Preliminary Findings from Review

of the USGS Study of the
Cuyama Valley Groundwater Basin

Cuyama Basin Water District

27 October 2017 | EKI B70069.00

**Representative Long-Term
 Hydrographs by USGS
 Study Area Zone**
 Cuyama Basin Water District
 Cuyama, California
 October 2017
 EKI B70069.00
Figure 8b

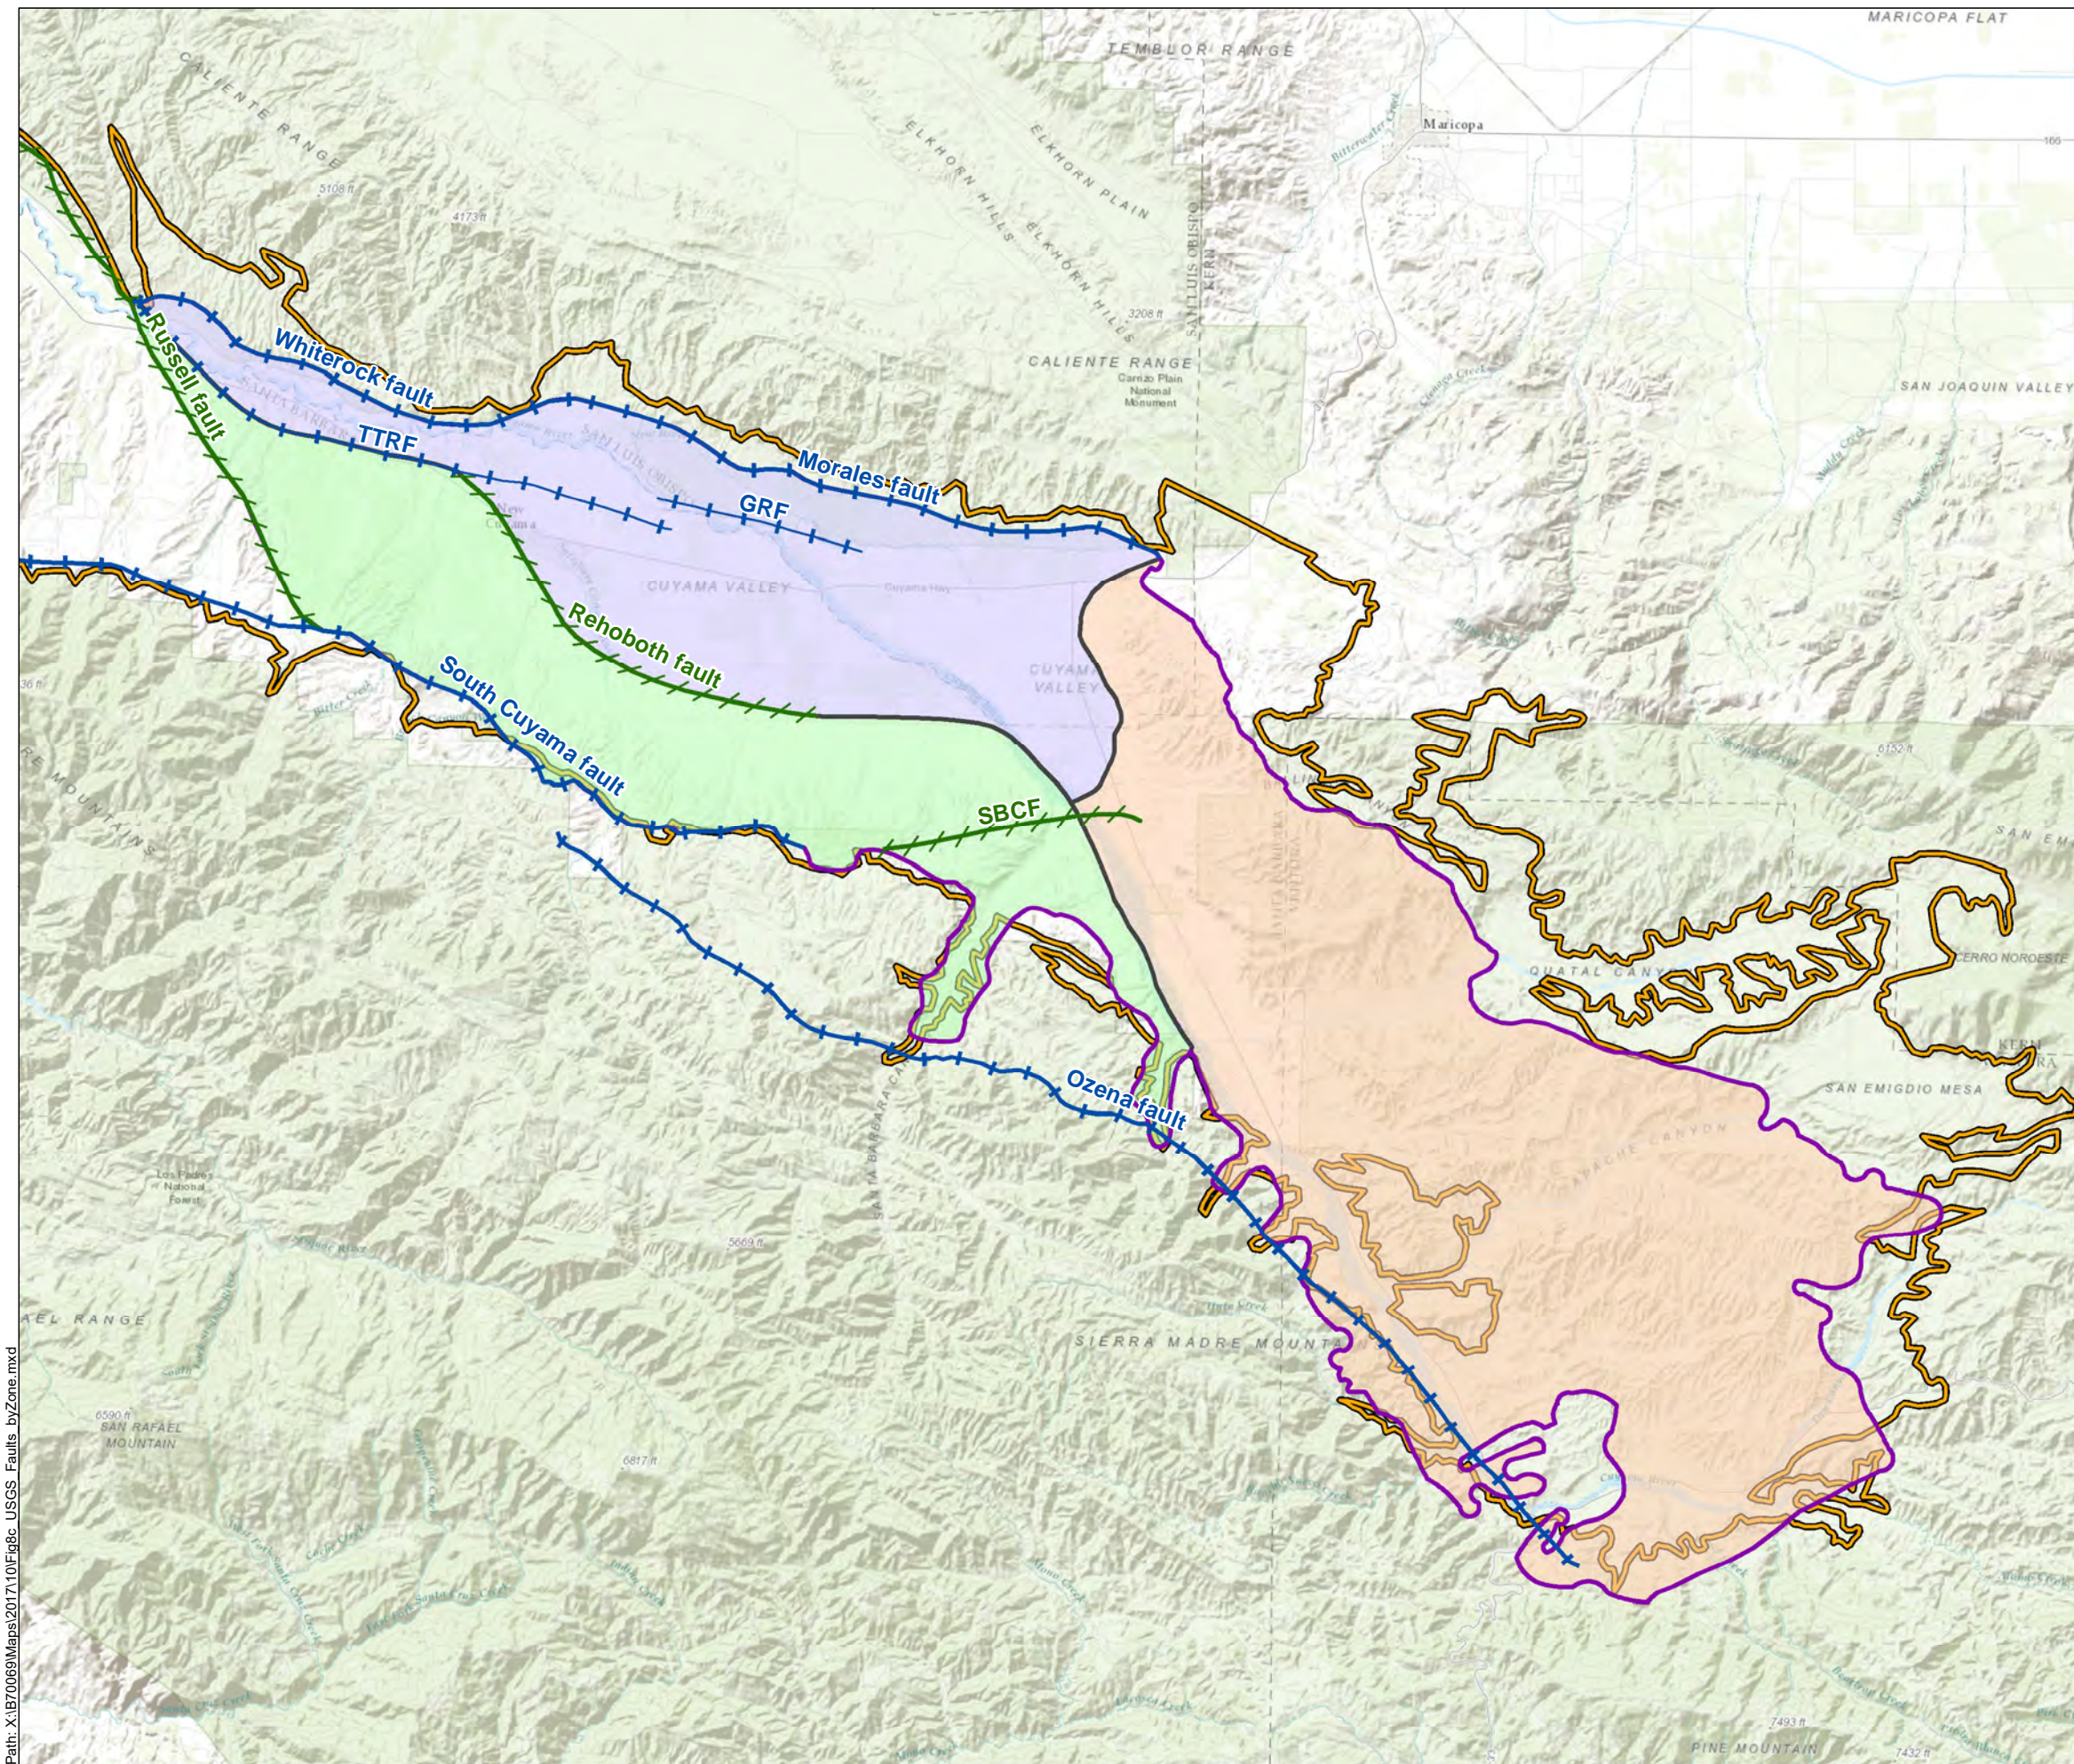
Figure 8b shows water level hydrographs for five representative wells within the USGS Study Area, based on data from 1940 through 2010 as provided in the USGS Study (additional hydrograph data are included in Appendix B). While significant local variability exists within the Basin, the five hydrographs shown are generally representative of wells in their respective areas and exhibit trends that appear to be influenced by water use patterns and their spatial position within the Cuyama Basin, not just by the presence or absence of hydrogeologic features or divisions as the USGS Study suggested.

- In the far southern portion of the Ventucopa Uplands zone, water levels in well CUY-30 are relatively close to the surface (i.e., less than approximately 50 feet below ground surface [“ft bgs”]), relatively stable over the long term, and show fluctuations linked to climate patterns. For example, the hydrograph shows the effects of the late 1980s/early 1990s dry period and subsequent mid 1990s wet period. These patterns suggest the influence of the nearby Cuyama River and the relatively low level of groundwater pumping in the area.

- In the Sierra Madre Foothills, well CUY-24 exhibits a steady downward trend from the early 1980s to approximately 2010. As this well is not located directly in an area of irrigated agriculture, this decline may be associated with overdraft occurring in the areas in the Main zone to the north. This would suggest that the two areas are in hydraulic communication to some degree, notwithstanding the USGS subarea boundary and inferred influence of the Rehoboth fault (see Figure 5). Further work may be needed as part of the GSP development process to better understand the hydraulic effects of these and other faults within the basin and the nature of hydraulic connections and variability within and between different areas.

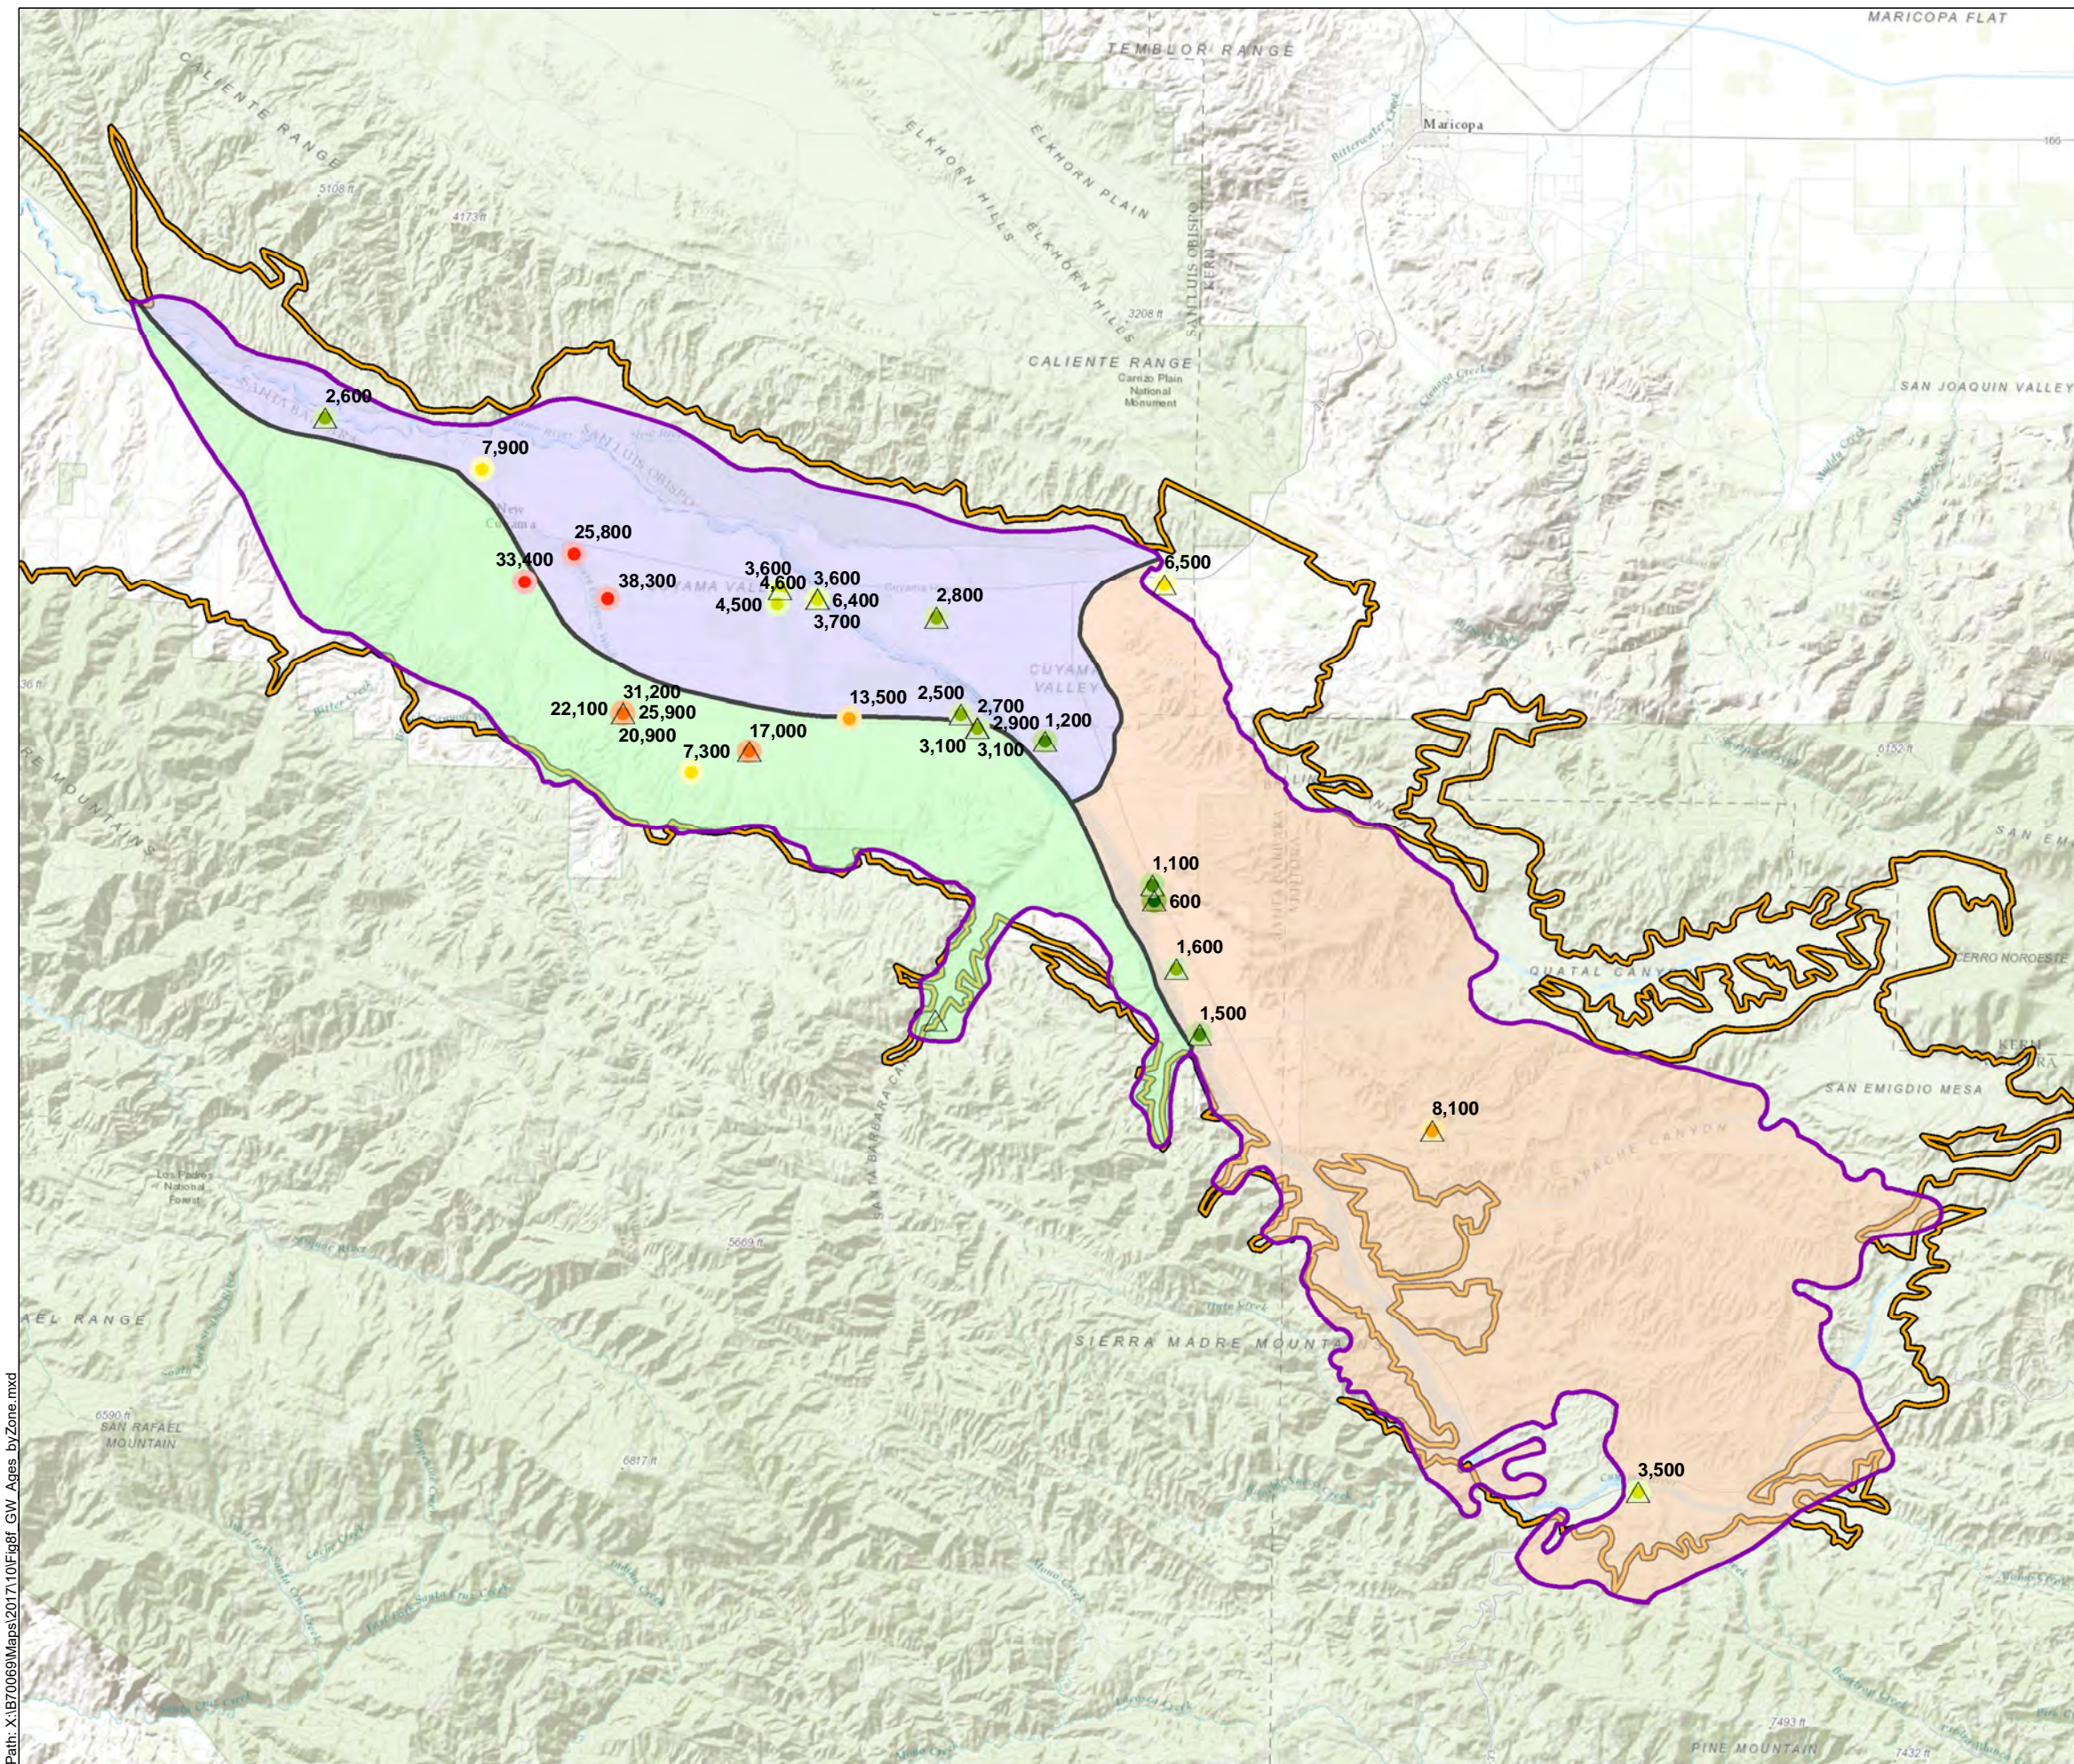
The EKI Team compiled all water quality data contained in the appendices of the Everett et al. (2013) report and plotted the major ions on a Piper diagram, color coding samples by their groundwater zone (see Figure 8e). Results of this exercise indicate that water types are not readily distinct between the different zones. Though significant variability
